SCI-823-0.00

S.R. 823 OVER S.R. 335 AND

LITTLE SCIOTO RIVER

STRUCTURE TYPE STUDY SUBMITTAL

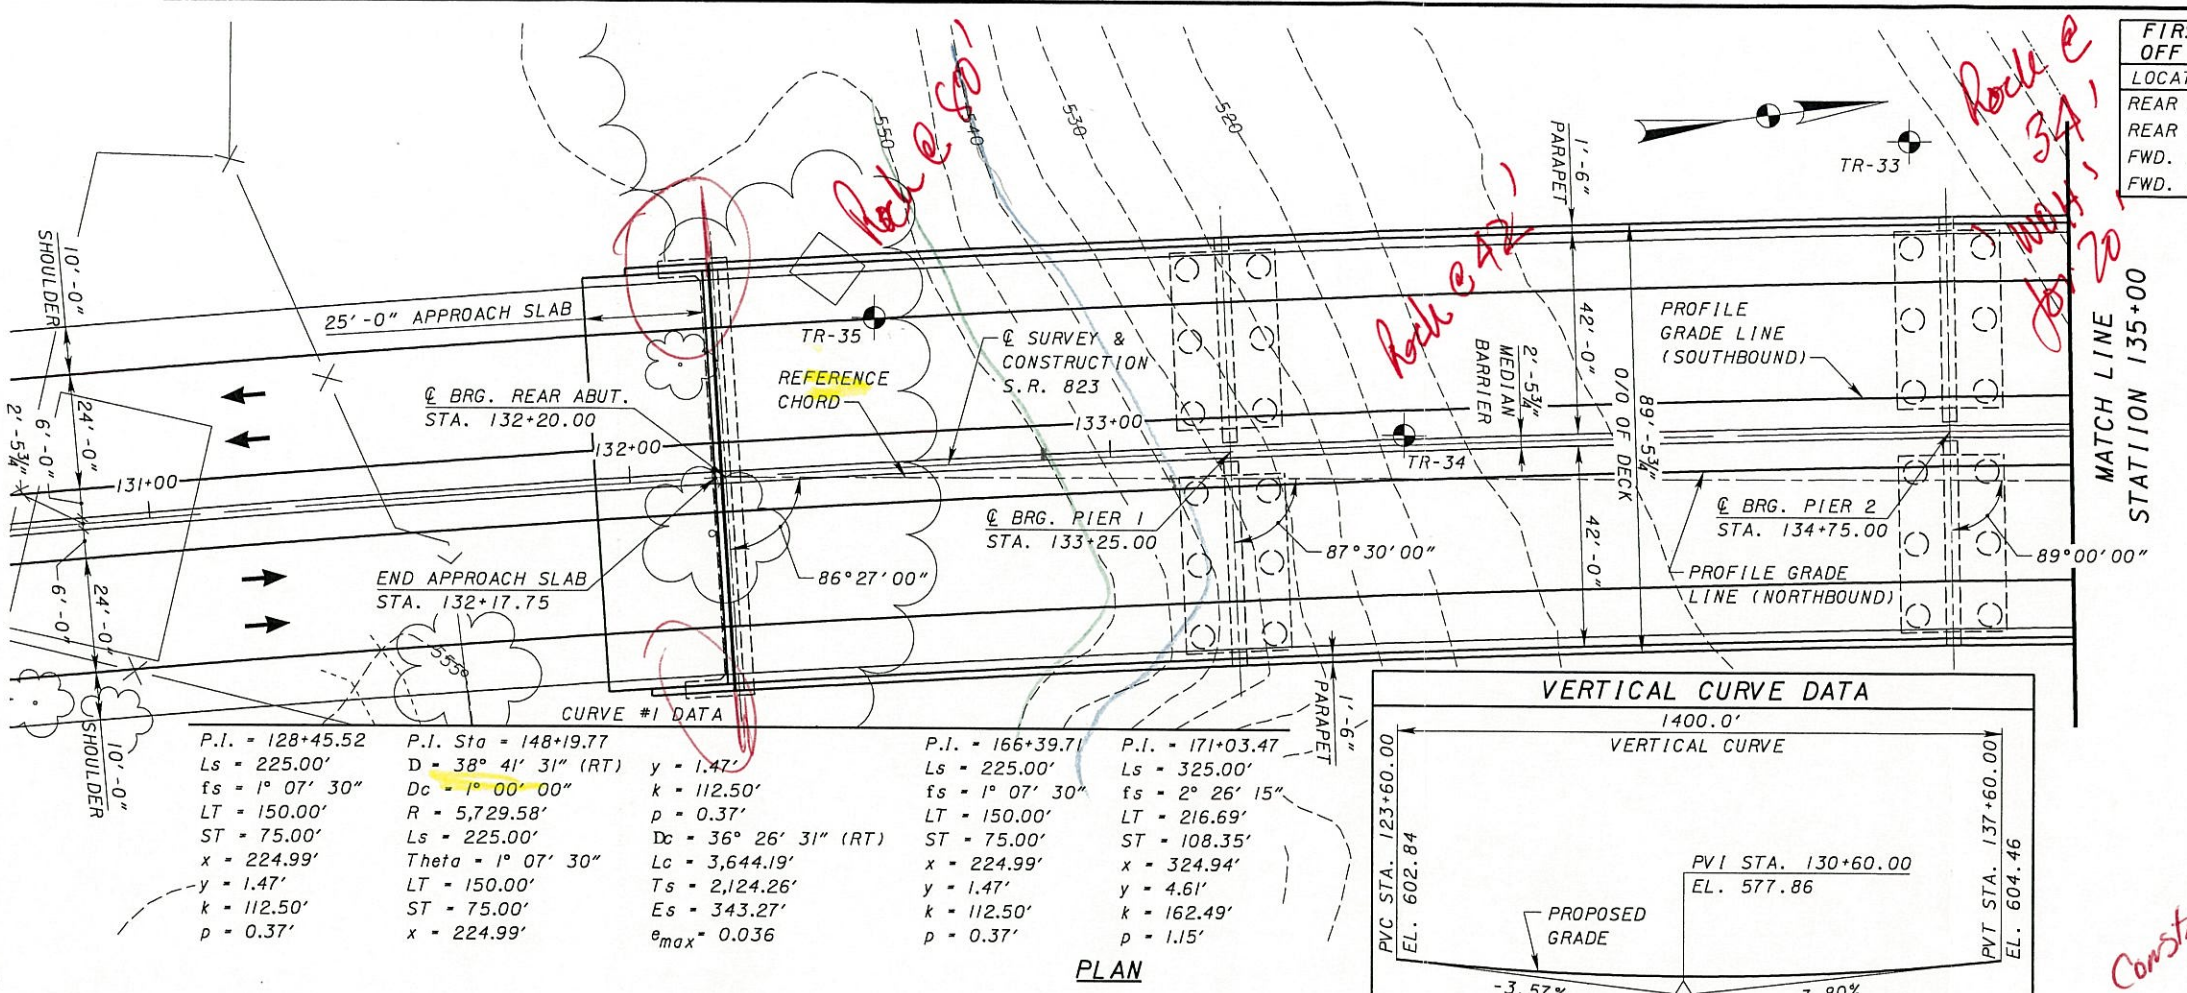
1.) MAXIMIZE SPACING ON GIRDERS

2.) Super vs substructure Costs
COMPARISON GRAPH ✓

3.) Question $H_{w,100} = 538$

4.) Stability Analysis

PROPOSED TRANSVERSE SECTION

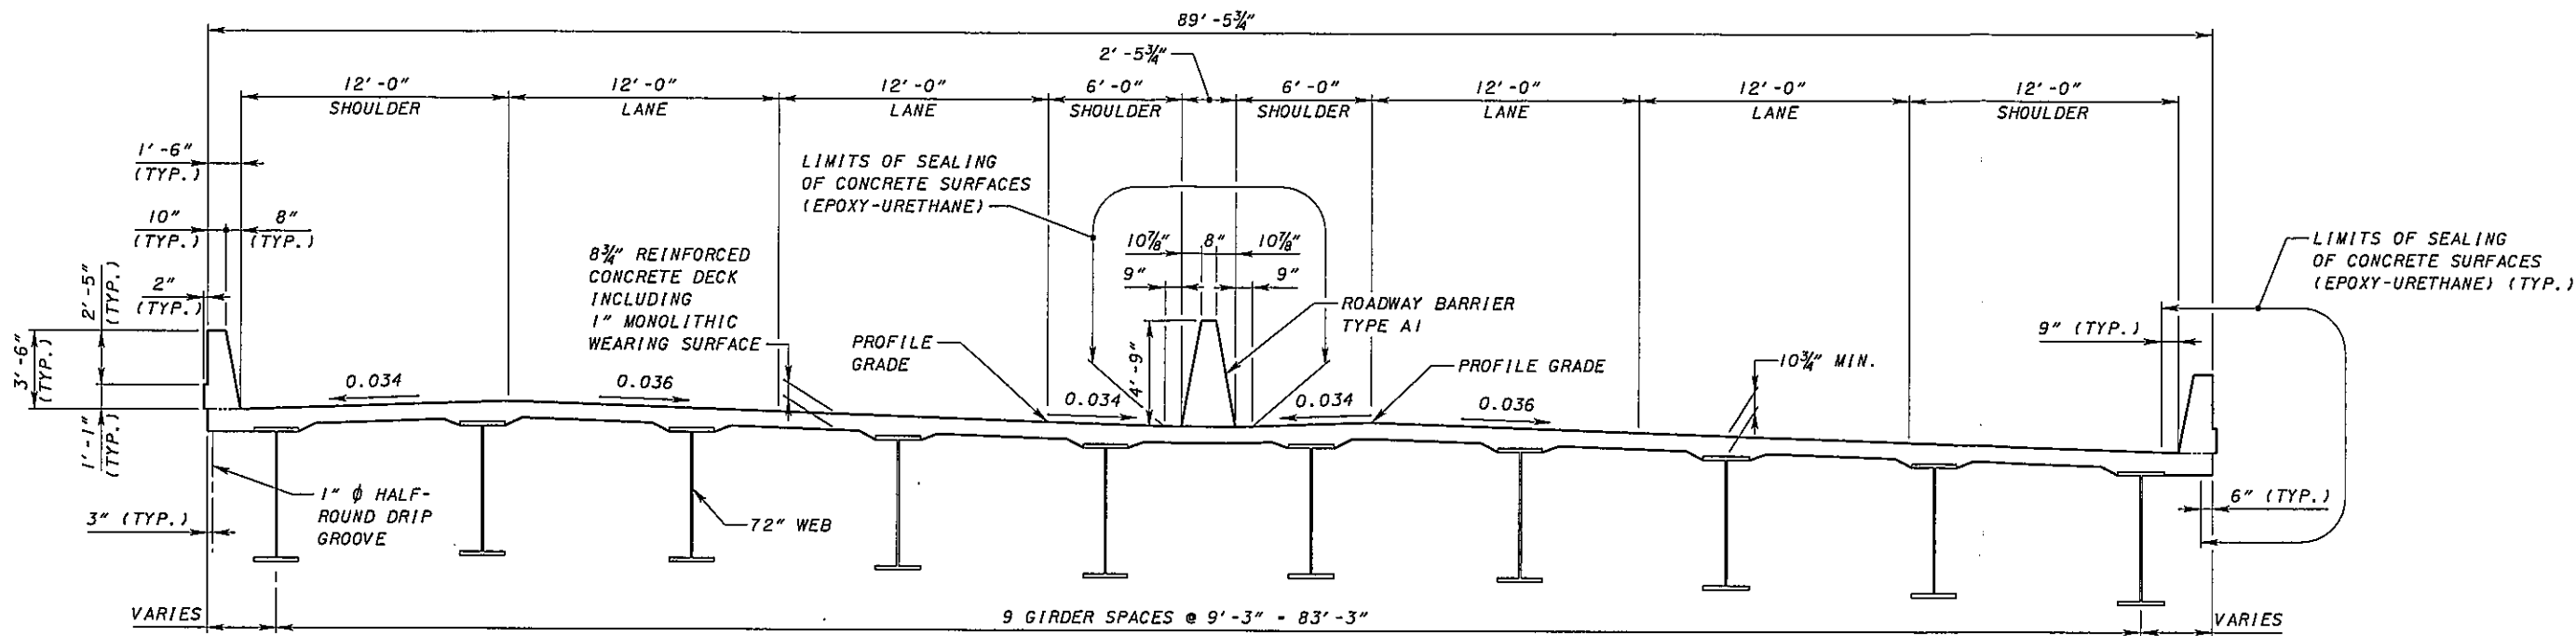
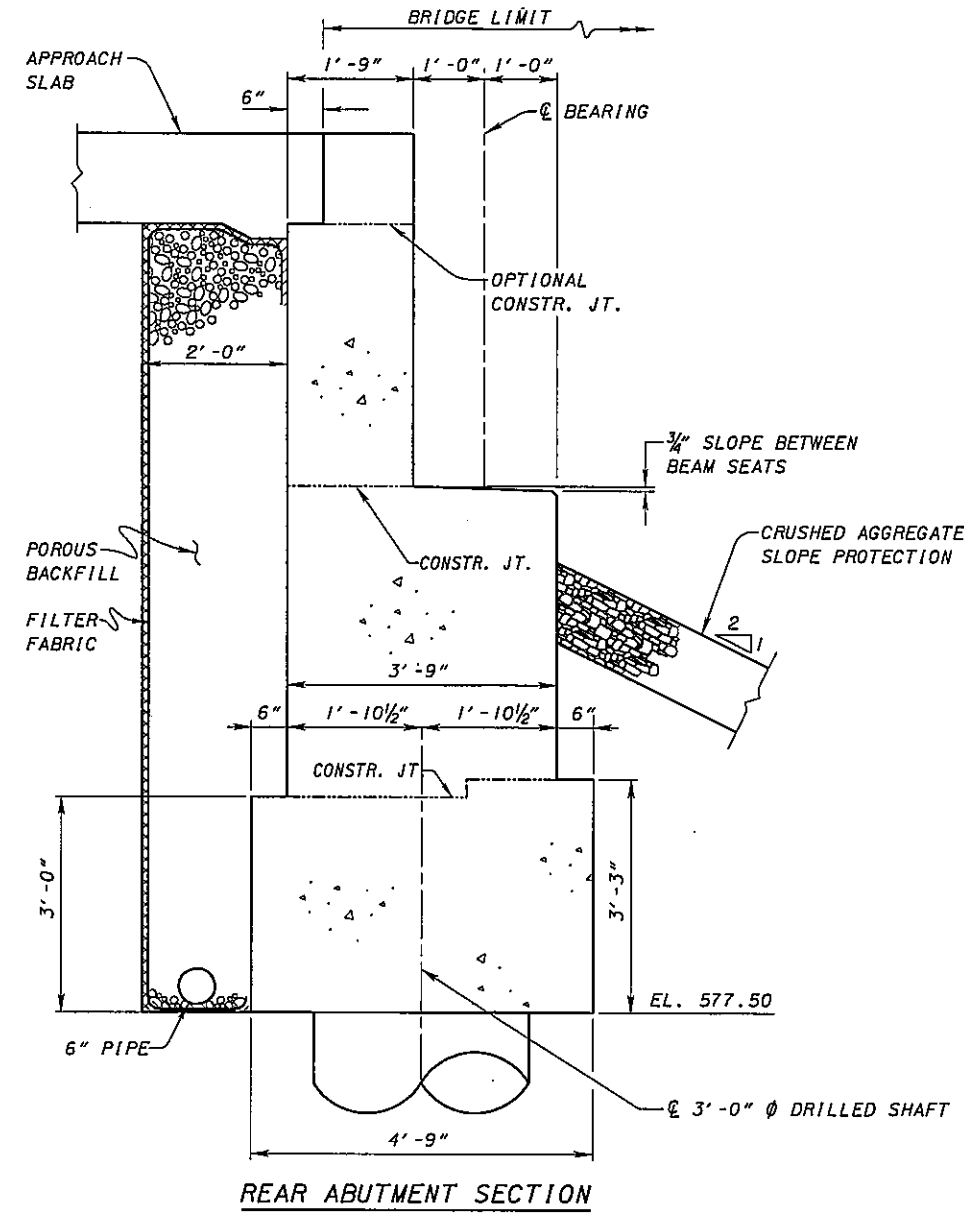
*Use 9 girders
 = spaces @ 12'*
